Application for Permission under Section 16 of the Town Planning Ordinance (Cap.131)
Temporary Public Vehicle Park (Excluding Container Vehicle) and Associated Filling of Land for a Period of 3
Years
in “Agriculture” Zone at Lots 1054 S.B and 1056 S.B (Part) in D.D. 106, Shek Kong, Yuen Long
(Planning Application No. A/YL-SK/464)

Submission of Further Information (3)

Response-to-Comments Table

drawing title. LAYOUT PLAN	
drawing no. PLAN 2	rev. scale - N.T.S.

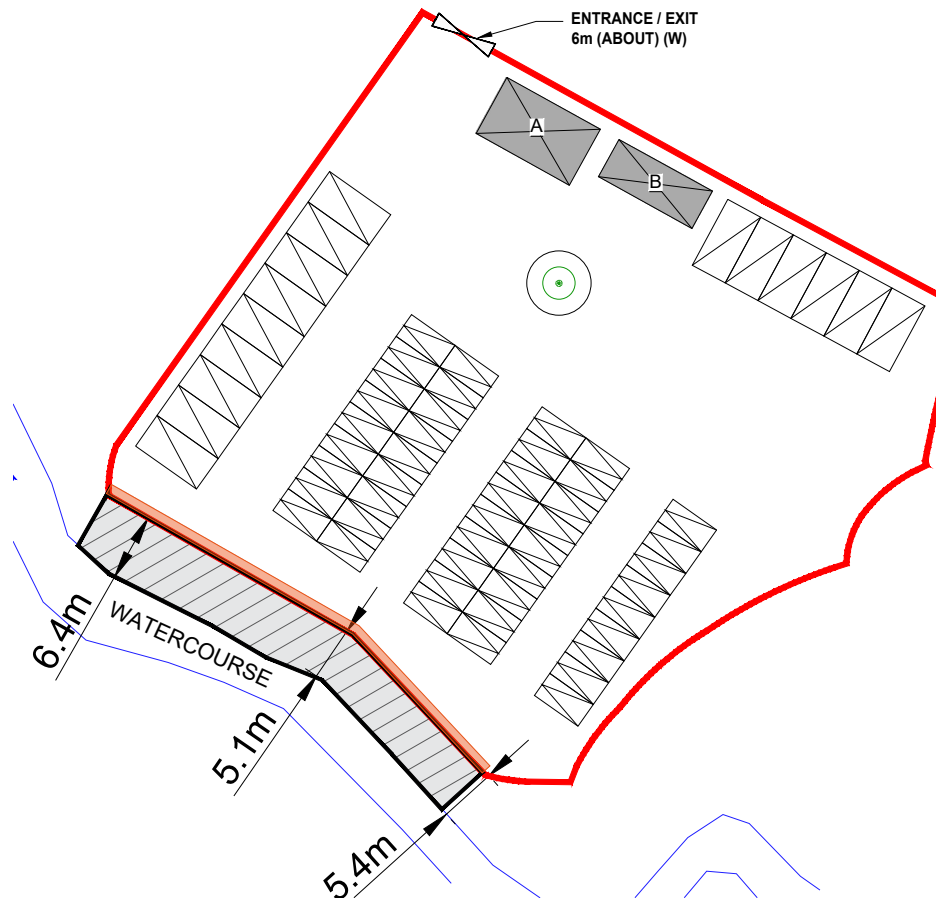
No.	Comments	Responses
1	Commissioner for Transport, Transport Department (Contact: Mr. Phil CAI), dated 21.9.2026 Given the size of the PVP and the potential traffic impact to the local road, the applicant shall conduct a traffic review to assess the traffic impact to Kam Sheung Road and the local access.	Noted. The applicant has reduced the number of private car parking spaces from 56 to 45 and the light goods vehicle parking spaces from 16 to 15. Please refer to the revised Plan 2 Layout Plan for reference. Given that the number of parking spaces is the same as the previously approved application A/YL-SK/430 and the proposed development would only induce an additional hourly average of 17 no. of vehicular trip along Kam Sheung Road and nearby road networks during peak hours, it is expected that the development would not generate adverse traffic impact to the local road (Attachment 4).

In view of TD’s comments, the applicant has reduced the number of private car parking spaces from 56 to 45, the light goods vehicle parking spaces from 16 to 15, and the application form, planning justifications and the estimated trip generation have been revised accordingly (**see attachments**).

2. The Site is for proposed temporary public vehicle park (excluding container vehicle) and associated filling of land for a period of 3 years. To cater the use of PVP, a total number of 45 parking spaces for private car (5m (L) x 2.5m (W)) and 15 parking spaces for light goods vehicle (LGV) (7m (L) x 3.5m (W)) are proposed. **Plan 2** illustrates the proposed layout of the parking spaces.
